5342A-58C-S

S E R V I C E N O T E

HP 5342A Microwave Frequency Counter

Support Strut for the HP 5342A Microwave Frequency Counter

Figure 1. HP 5342A/43A/44A Orientation and Support Strut Installation

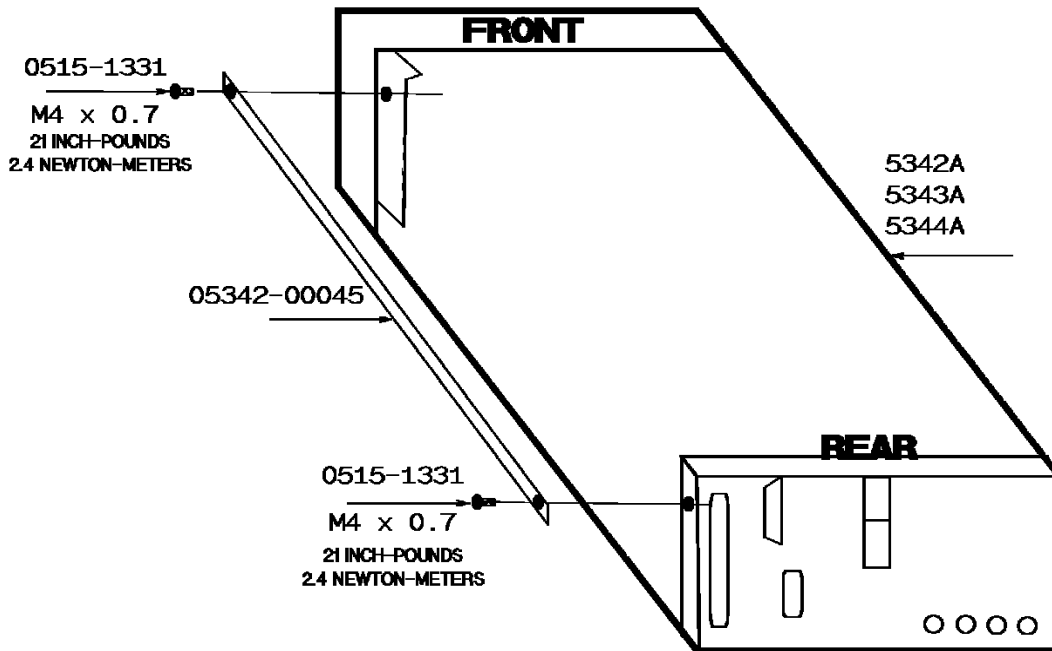
The cabinet framework of HP 5342A/43A/44A Microwave Frequency Counters and HP 5344A Microwave Source Synchronizers with serial prefix 2636A and below does not ensure that the front and rear castings will remain in parallelism. When the front and rear castings are out of parallelism, it creates a condition where the top cover may not be fully captured, and could work loose upon application of an added force. Since the carrying handle is attached to the top cover, the unit could fall if it is lifted by the handle.

Installing a support strut eliminates this potential safety problem.

1. At top rear of HP 5342A/43A/44A, remove pozidrive screw from rear cap retainer and remove retainer.
2. Slide top cover back until free from frame and lift off.
3. Attach support strut, P/N 05342-00045, to the top left side of the cabinet framework with two metric screws, P/N 0515-1331. See Figure 1 for proper orientation of the HP 5342A/43A/44A.

4. Measure the top cover from the front end to the fold of the back end. If it measures less than 469.6mm, then replace the top cover with P/N 05342-60074. Add Operating Label, P/N 7120-6827, to the new Top Cover.
